SUBJECT: INITIAL EXAMINATION REPORT NO. 50-150/OL-06-01, OHIO STATE
UNIVERSITY

U. S. NUCLEAR REGULATORY COMMISSION
OPERATOR LICENSING INITIAL EXAMINATION REPORT

Comments on SRO License Exam
for Kevin Herminghuysen Proctored on 05-23-2006
OSU Nuclear Reactor Lab - Docket # 50-150

OSU Reactor Shim-Safety Control Rod Assembly

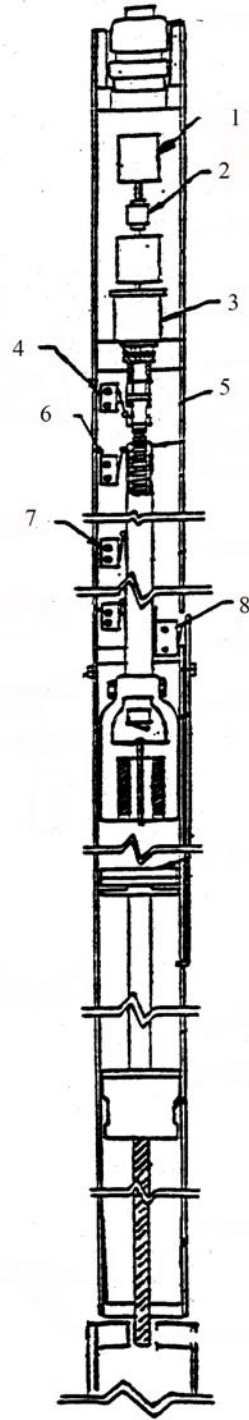
- C.14 Based on Attachment C to Procedure OM-11, the following answers should be given:
- a. Down switch – not numbered on figure
 - b. Drive motor – 3
 - c. Position indicator - 1

- d. Up switch – 6

NRC Resolution: All comments accepted as written.

C.14 a, 7 b, 23 c, 1 d, 46 Answers changed per facility comment.
